UNITED STATES PATENT AND TRADEMARK OFFICE

APPLICATION NO.	FILING DATE	FIRST NAMED INVENTOR	ATTORNEY DOCKET NO.	CONFIRMATION NO.
10/816,148	04/01/2004	Stefan Bodenschatz	104035/282200	9008
826 7590 03/06/2009				
ALSTON & BIRD LLP				
BANK OF AMERICA PLAZA				
101 SOUTH TRYON STREET, SUITE 4000				
CHARLOTTE, NC 28280-4000				
EXAMINER				
AMERSON, LORI BAKER				
ART UNIT		PAPER NUMBER		
3764				
MAIL DATE		DELIVERY MODE		
03/06/2009		PAPER

Office Action Summary**Application No.**

FIG. 6

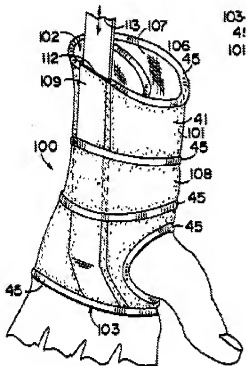
a. Claims 1-8 are rejected under 35 U.S.C. 103(a) as being unpatentable over Peters in view of Szlema. Peters discloses: an anatomically shaped section (see figure 2 below) which receives the wrist and the hand (see figure 6 below) and which is formed from a single piece of flexible and elastic material (see col. 2, lines 48-50) , the section narrowing (see fig. 2 below) in the proximal direction, the section having, on the medial edge, a cutout for receiving the thumb 104, and with at least two straps 105,108 secured on the medial edge, which straps can, be secured on the dorsal side of the bandage (see col. 4. lines 11-21), and with a pocket 110 which is secured on the palmar side of the bandage (see col. 3, line 58-68 thru col. 4, lines 1-10), in particular sewn (col. 2, line 25) thereon.

FIG. 2

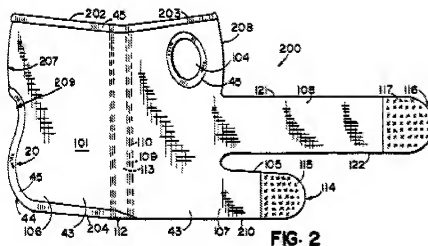
Peters discloses all of the limitations except for the centre axis of the pocket forming an inwardly directed arch shape or an inwardly directed kink and the kink enclosing an

angle between 150 to 170 degrees nor the bandage made from a material which is substantially inflexible in the proximal and distal direction. Thus Szlema et al teaches in a kink having an enclosed angle between 40-60 degrees and an inflexible material. As to the shape of the pocket, at the time the invention was made, it would have been an obvious matter of design choice to a person of ordinary skill in the art to shape a pocket by the arch of a limb because Applicant has not disclosed that shaping the pocket provides an advantage, is used for a particular purpose, or solves a stated problem. One of ordinary skill in the art, furthermore, would have expected Peters bandage, and applicant's invention, to perform equally well with either the shape taught by Peters or the claimed arch or kink because both of the bandages would perform the same function of supporting the limb. Therefore, it would have been to modify Peters in view of Szlema et al to obtain the invention as specified in claim because such a modification would have been considered a mere design consideration which fails to patentably distinguish over the prior art of Peters. See also MPEP 2144.04, subsection IV. A. – change in size or proportion. As to the angle, it would have been obvious to one having ordinary skill in the art at the time the invention was made to enclose the kink at an angle from 150 to 170 relative to the requirement of the user's hand position, since it has been held that where the general conditions of a claim are disclosed in the prior art, discovering the optimum or workable ranges involves only routine skill in the art. In re Aller, 105 USPQ 233. As to claim 4, the straps are provided with a hook and loop closure 115 which is secured on a roughened surface (see col. 2, line 19), the roughened surface being secured on the dorsal side of the bandage. As to claim 5, as
